Access Compliance Report

Public Rights-of-Way

(Curb Ramps)

Intersection ID: 11660	Main Street: E_20TH_ST	Cross Street: HARRILL_ST	Location: W
ADA ID: A7DA33B72344	Ramp Type: BlendTrans1	Initial Pass/Fail: Fail	Overall Compliance: No
Severity Score: 17.5			
Codes/Mitigation Info/Possible Solution		Field Measurements/Component Compliance

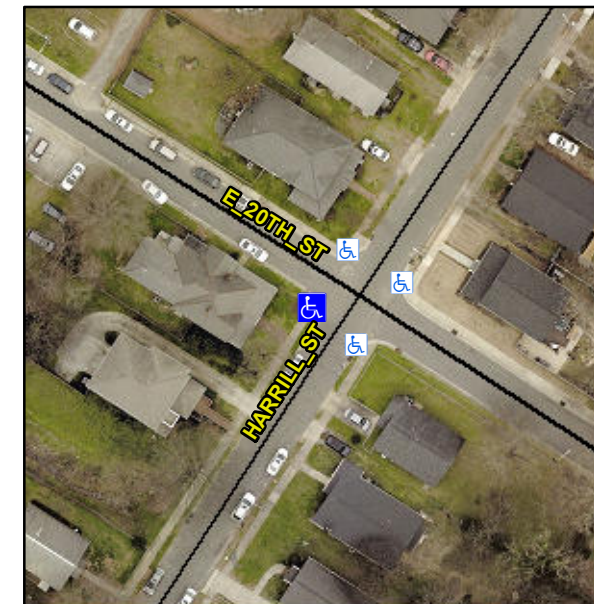
RP < 5%

Not Found, R304.5.1

Compliance	Description	Data	Compliance	Description	Data
N/A	Ramp Length (in)	40.0	Yes	BlendTrans Slope (%)	3.4
No	Ramp Width (in)	35.0	Yes	BlendTrans XSlope (%)	1.2
N/A	Flare Type LT	N/A	N/A	Flare Type RT	N/A
N/A	Flare Slope LT (%)	N/A	N/A	Flare Slope RT (%)	N/A
N/A	Flare Traversable LT?	N/A	N/A	Flare Traversable RT?	N/A
N/A	Landing Length (in)	N/A	N/A	DWS Provided?	N/A
N/A	Landing Width (in)	N/A	N/A	DWS Contrast?	N/A
N/A	Landing Slope (%)	N/A	N/A	DWS Length (in)	N/A
N/A	Landing X Slope (%)	N/A	N/A	DWS Full Width?	N/A
N/A	Landing Curb? (Y/N)	N/A	N/A	DWS Offset (in)	N/A
N/A	Shared Landing?	N/A			
N/A	Gutter Ponding?	N/A	N/A	Gutter Slope (%)	N/A
N/A	Gutter Lip Ht (in)	1.0	N/A	Gutter X Slope (%)	N/A
N/A	Painted X Walk1?	No	N/A	Painted X Walk2?	No
	X Walk 1 Direction	To SE		X Walk 2 Direction	To NE
	X Walk 1 Width (in)	N/A		X Walk 2 Width (in)	N/A
	X Walk 1 Slope (%)	2.6		X Walk 2 Slope (%)	5.6
	X Walk 1 X Slope (%)	3.9		X Walk 2 X Slope (%)	0.7

N/A	Ramp inside XWalk1?	N/A	N/A	Ramp inside XWalk2?	N/A
	Road Slope (%)	6.2		Clear Space?	N/A
	Road X Slope (%)	1.7	N/A	Clear Space to XWalk (in)	N/A
N/A	Any Obstructions?	N/A	N/A	Storm Grate/Utility Hazard?	N/A
	Obstruction Type			Storm Grate/Utility Type	
		N/A			N/A
			Yes	Surface Condition? (G/P)	Good
			No	Curb Slope (%)	21.9

Remove & Replace Curb Ramp With Two New Directional Ramps or Equivalent.
